1. Nemeth Mixed Use Development

STAFF REPORT – DESIGN REVIEW

Permit Number: PLN-2020-0044

Project Components: Design Review for construction of 105 apartments and approximately 7,350 s.f. of ground-floor retail on a 3.7-acre vacant site. Development will include on-site parking lot, creation of on-street parking stalls, public trail, open space, utilities, plaza and landscaping.

SHEET CONTENTS:
SITE PLAN

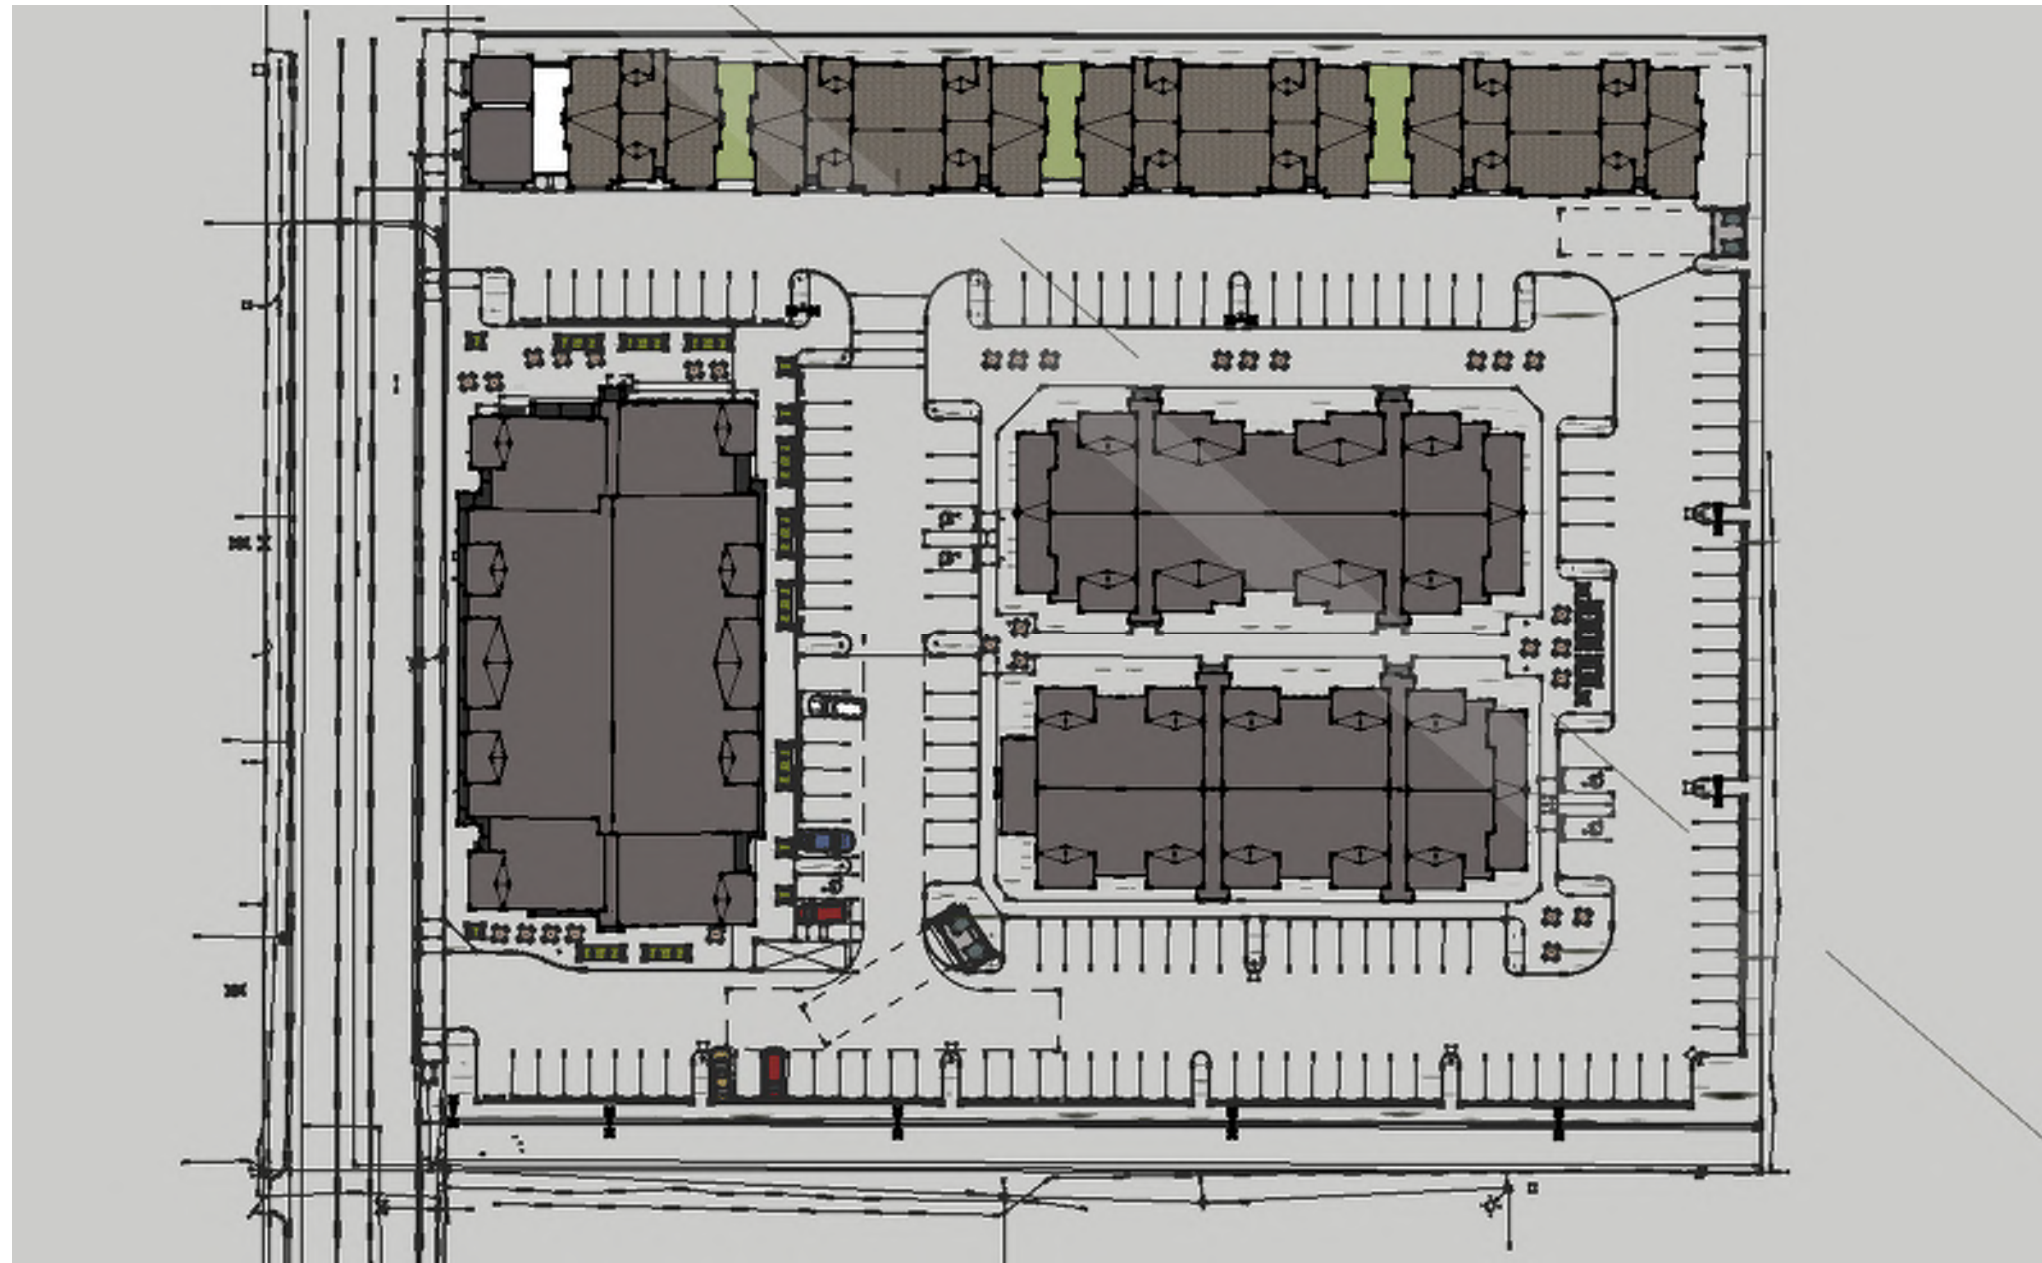
The project plans and building elevations do not identify locations or address screening of all utilities. This is particularly important along the street frontages and pedestrian oriented space and plazas.

Staff recommends that prior to building permit approval, plans show how utility equipment will be addressed:

- a. Identify locations on the landscape plan and site plan.
- b. Demonstrate that utilities do not interfere with minimum required open space.
- c. Provide details of how utility equipment is screened with landscaping or architectural features.

SHEET CONTENTS:
EXTERIOR ELEVATIONS

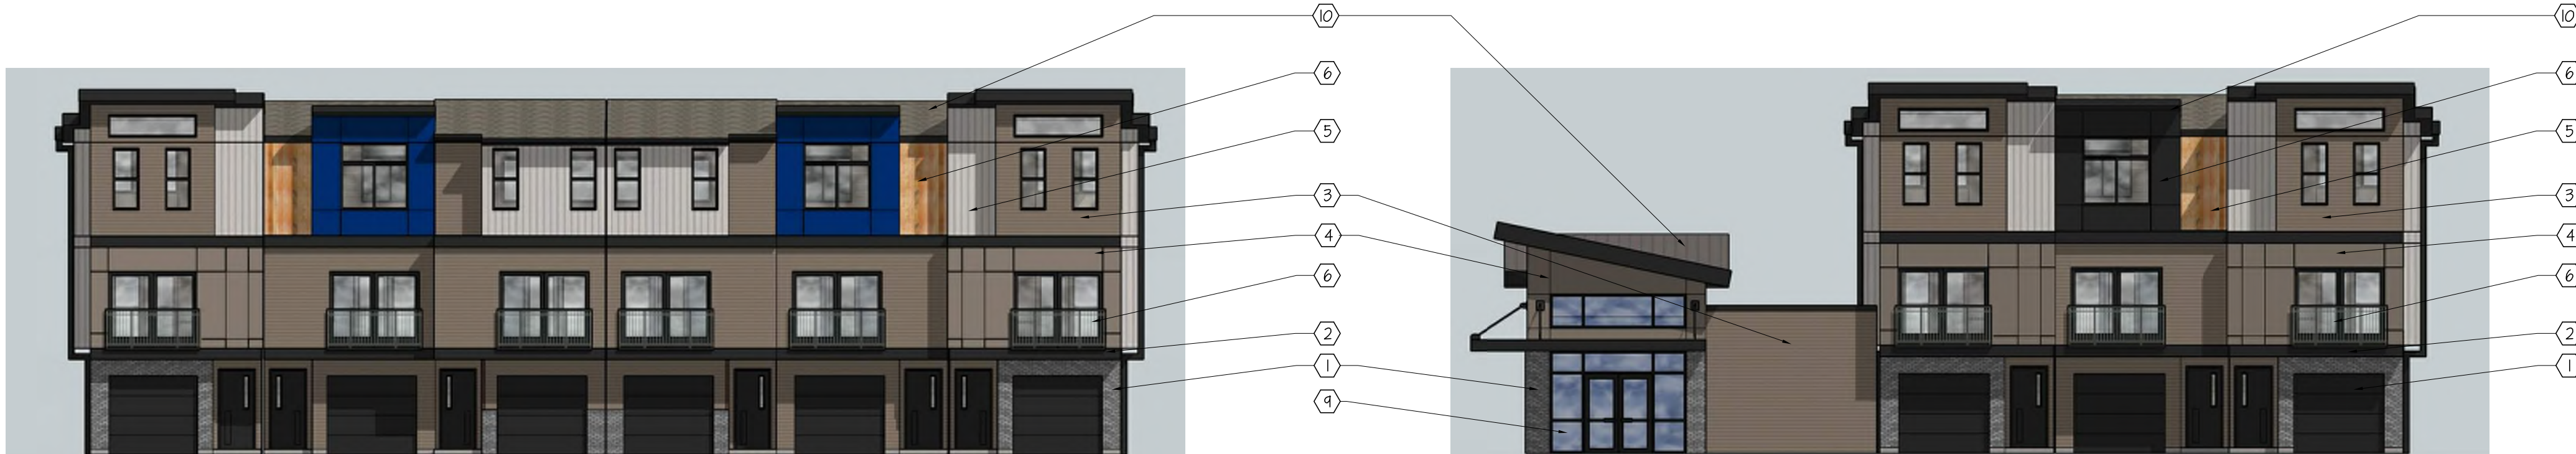
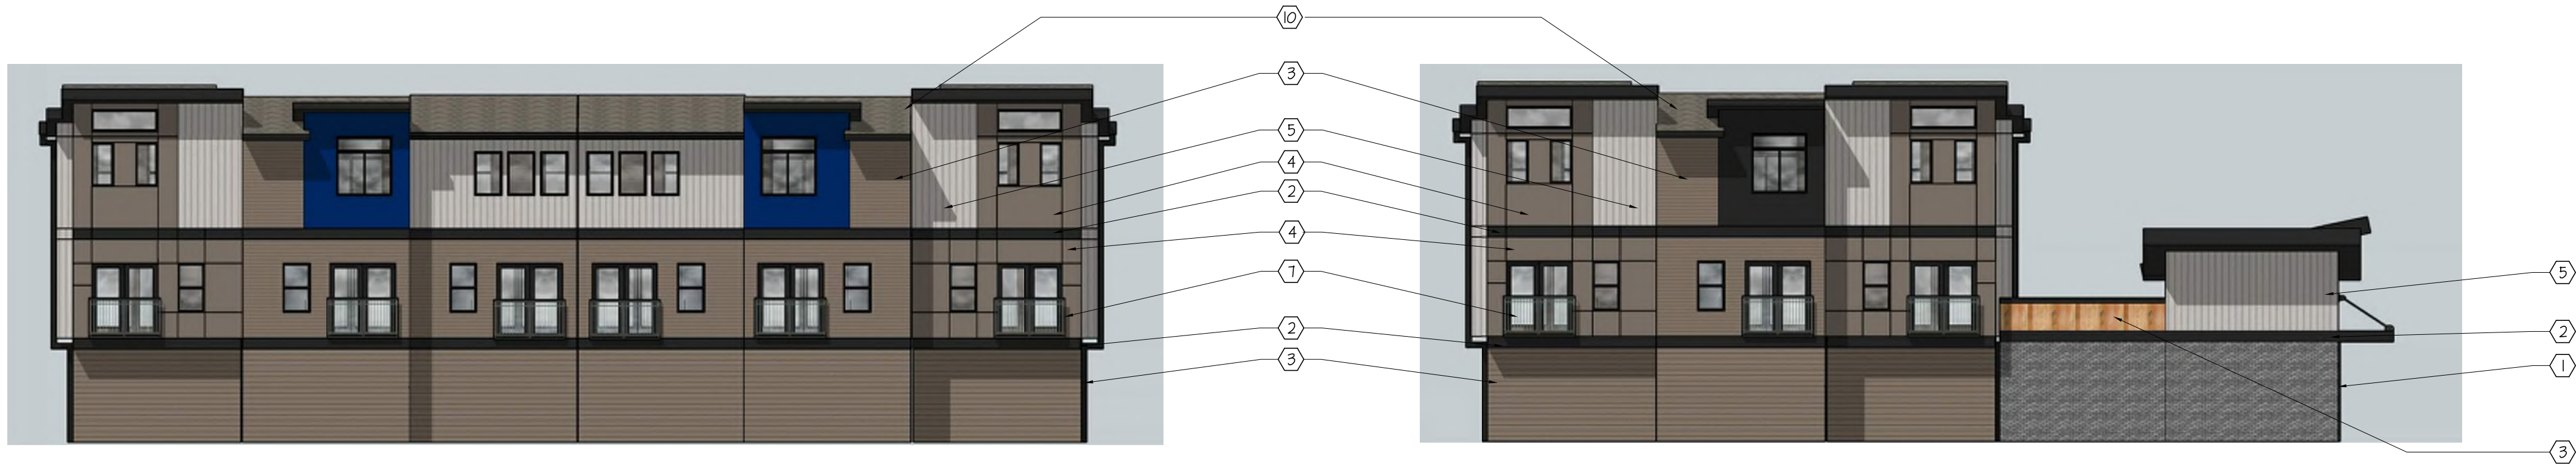
The proposed townhouse elevations show individual articulation and modulation on the townhouses, through the use of color and material changes. Overall, the townhomes provide areas of great design and modulation/articulation while still needing some added details and changes in some areas. This guideline is met as conditioned and discussed in guideline 3.7.1.

There are 7 buildings that include residential uses on this site. Currently staff feels that the townhome buildings are too similar especially considering they are in a row adjacent to each other. While staff also feels buildings 2 and 3 are similar, they are flipped to provide subtle changes from each other. The changes recommended throughout this report would aid in diversifying the building types. This guideline is met as conditioned throughout the report.

- a. BLD 2-3 shall provide a more distinct change from the buildings bottom and middle sections or articulation of the material changes.
- b. Townhomes – Each of the 6 plex buildings are very similar and should include some measures to create more variety between them. This could be accomplished alternating the layout (flipping internal and outside units), changing colors and
